1995 WIGWAM RD
EL PASO COUNTY, CO

**GRADING & EROSION CONTROL PLAN
GRADING PLAN**

C1.2 MVE PROJECT 61180
MVE DRAWING GEC-GP

GRADING & EROSION CONTROL PLAN
POND PLAN

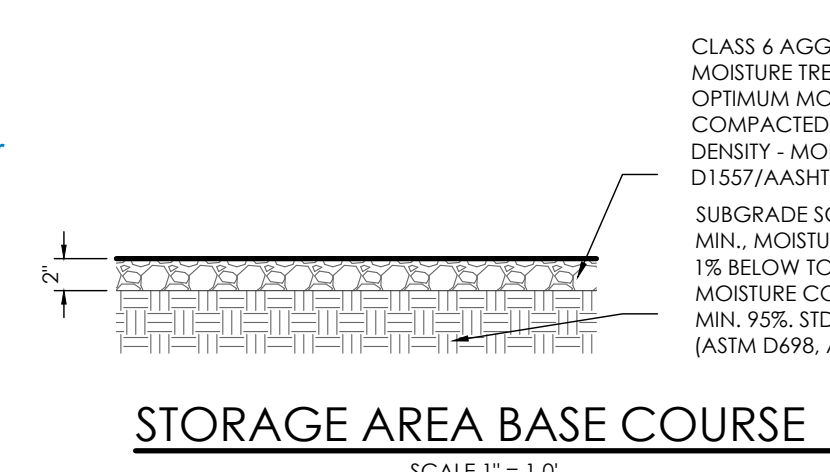
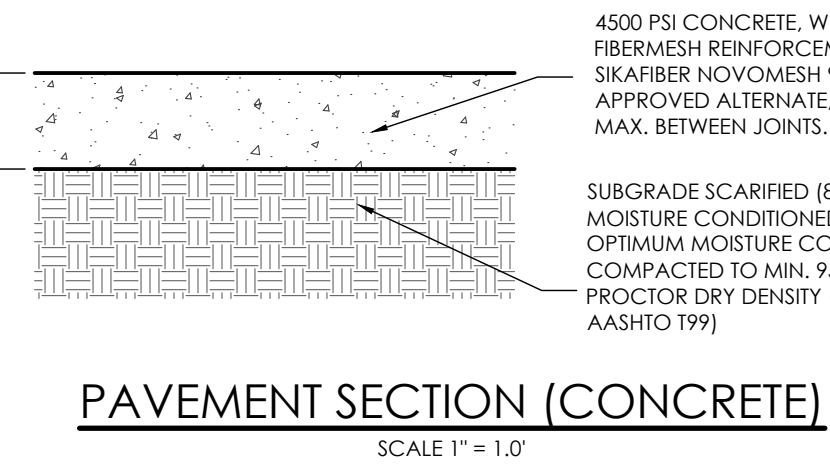
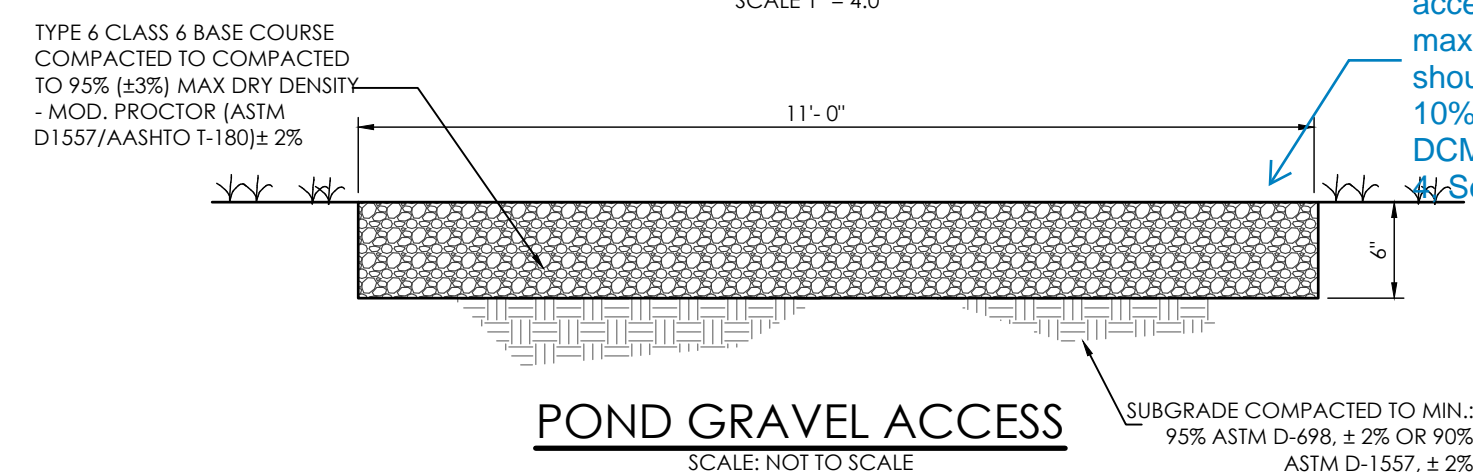
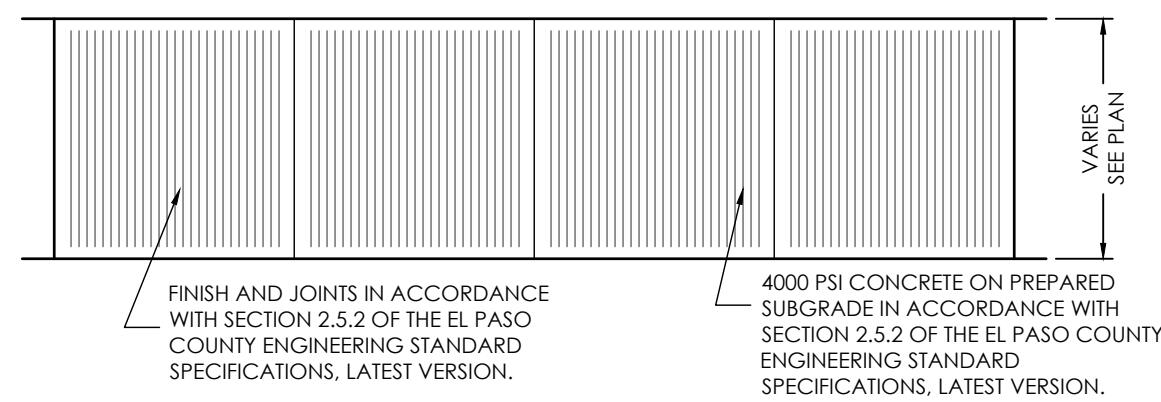
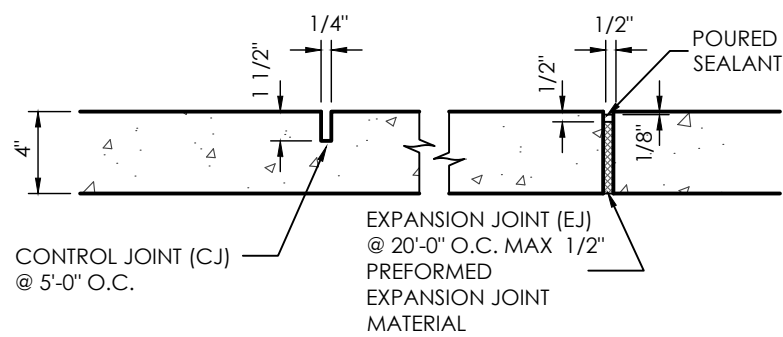
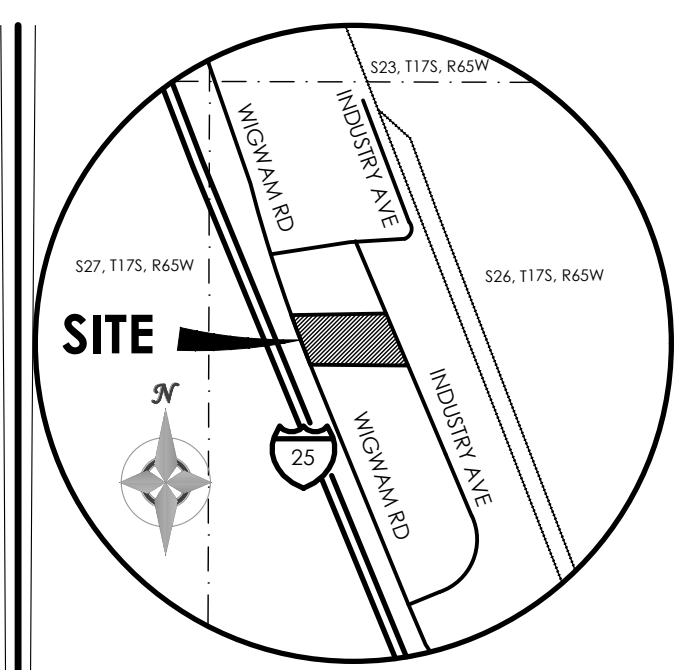
GEC Checklist Item ee - Prior to project approval the cover sheet and all pages will need to be stamped/signed.

- 13 INSTALL CONCRETE SPILLWAY & EMERGENCY OVERFLOW RIP-RAP (SEE POND PLAN)
- 14 INSTALL PRIVATE HDPE STORM PIPE W/ FES AT OUTLET (SEE STORM PLAN) *It appears that storm plan was not included in the first submittal.*

Please show and label all curb and gutter (type). This comment is applied to both drainage maps.

Please show and label drainage easement for proposed swales, pond, storm sewers.

Plan and profile of storm pipe is required.

How can erosion be prevented at the highlighted gap areas.

Mountable curbs are recommended at any section that maintenance access crosses the trickle channel.

Please label spillway riprap (ownership, condition, type, size), and spillway flow direction.

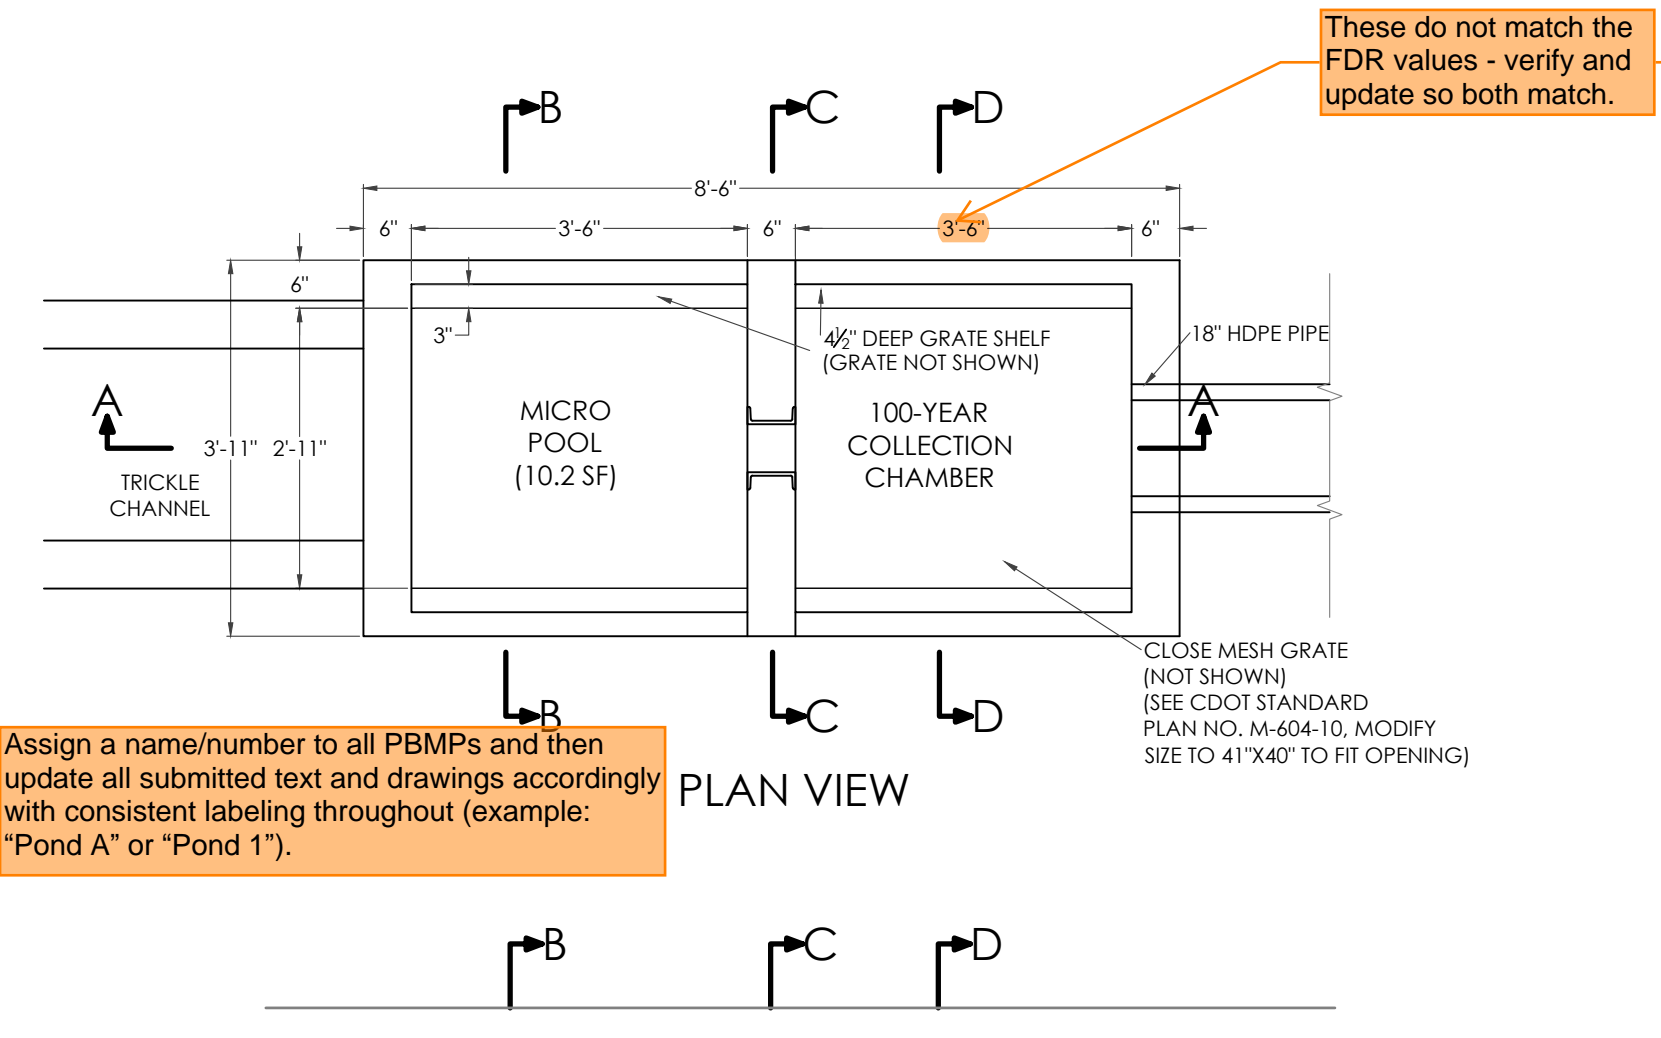
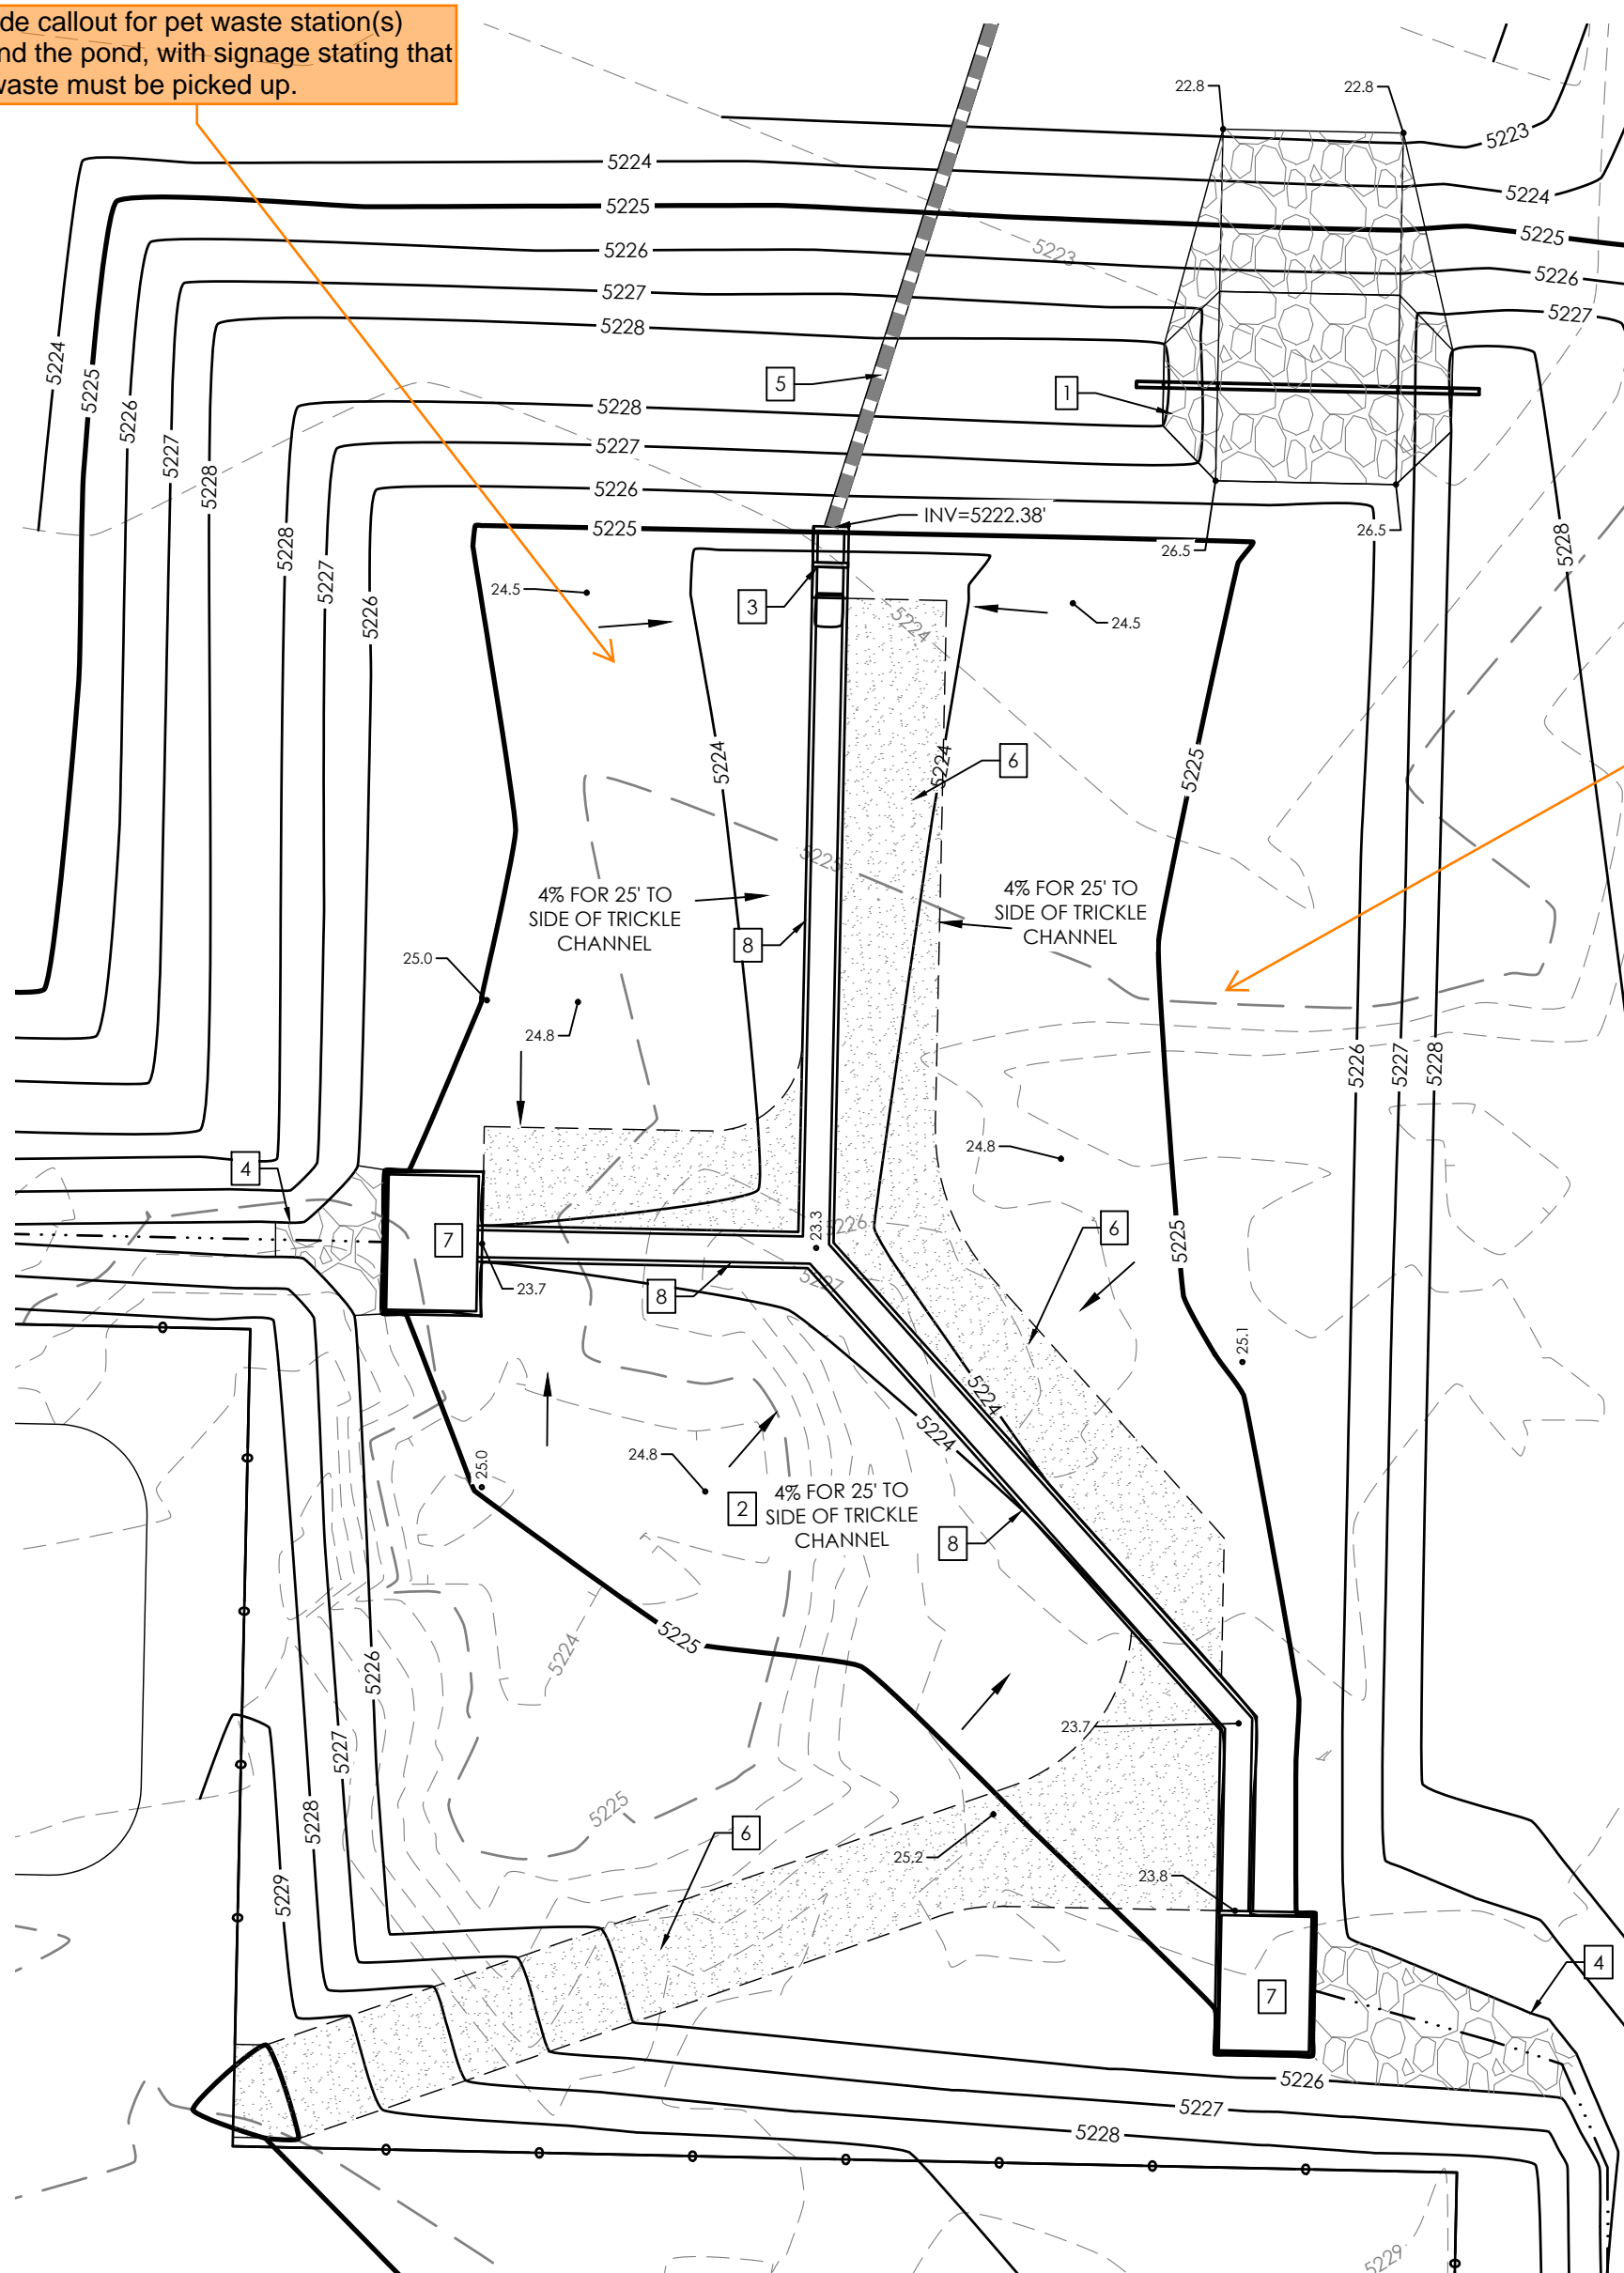
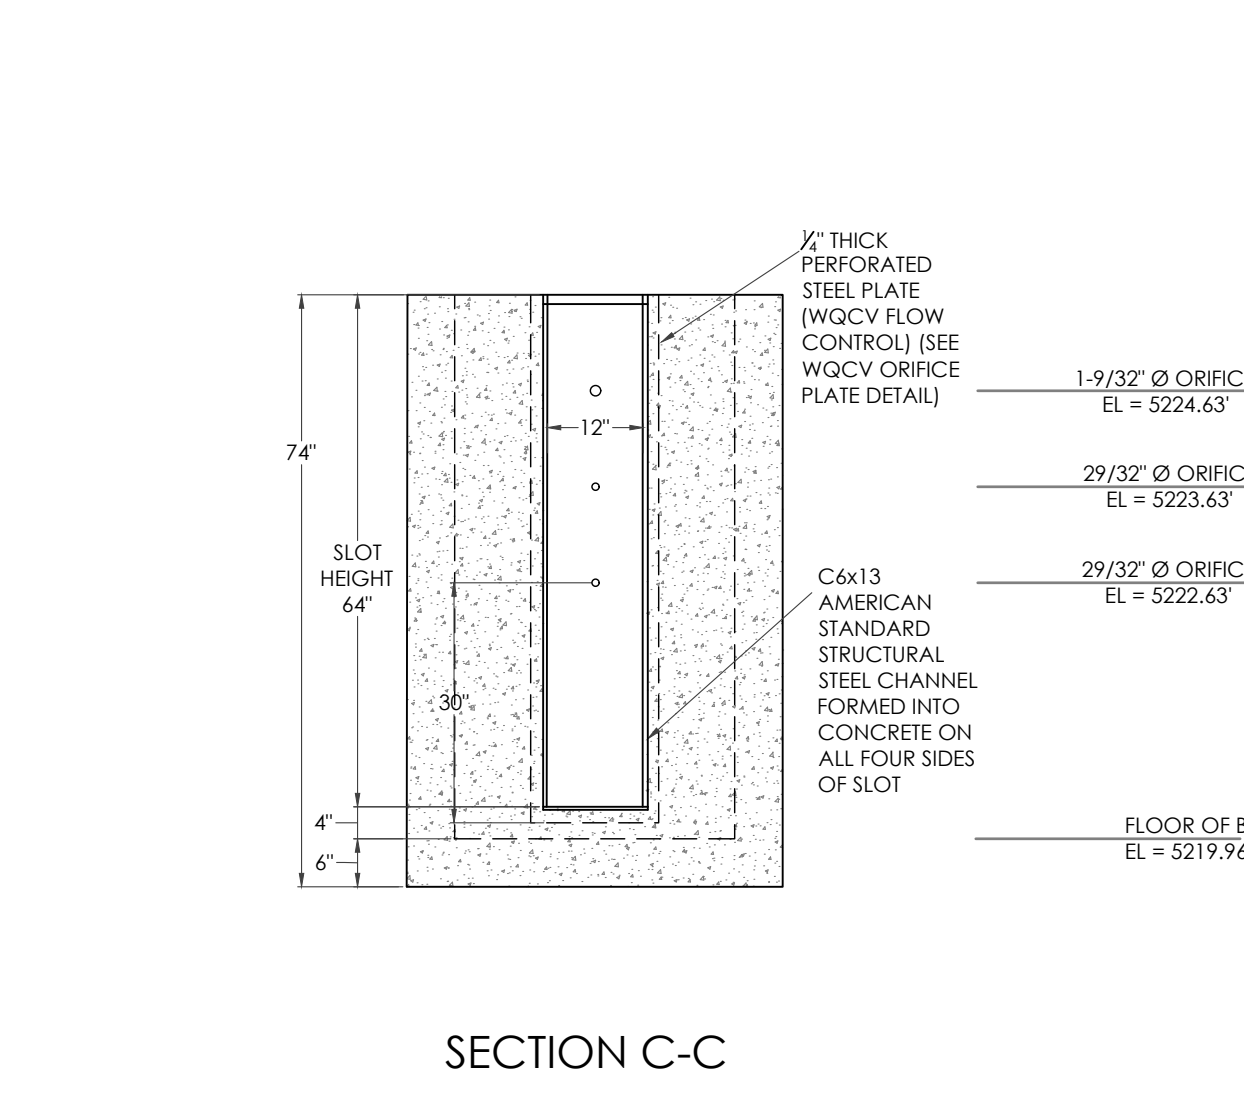
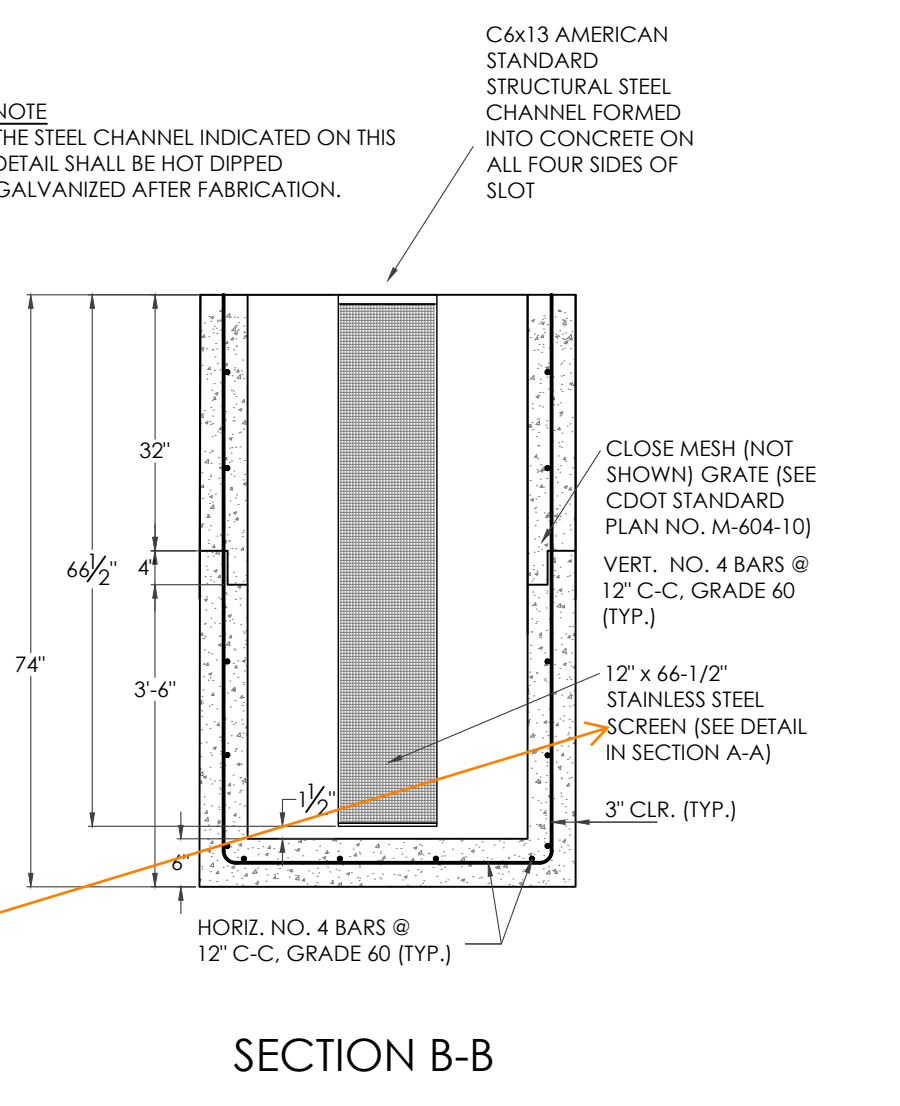
Include callout for pet waste station(s) around the pond, with signage stating that pet waste must be picked up.

These do not match the FDR values - verify and update so both match.

Assign a name/number to all PBMPs and then update all submitted text and drawings accordingly with consistent labeling throughout (example: "Pond A" or "Pond 1").

Specify well screen type. Trash rack to be Johnson stainless steel well screen with #93 VEE wire (Figure 6-a), or equivalent (per EPC DCMv2, Chap 4.3 and MHFD Detail T-12).

show interface between riprap rundown and forebays so it is clear how the two are designed to meet

Number 9 was not shown on the plan. Warning sign location for the pond needs to be shown on the map.

Details of trickle channel, and forebays cannot be fully reviewed without calculations.

Consider having control joints every ~10ft.

show forebay notch view and dimensions.
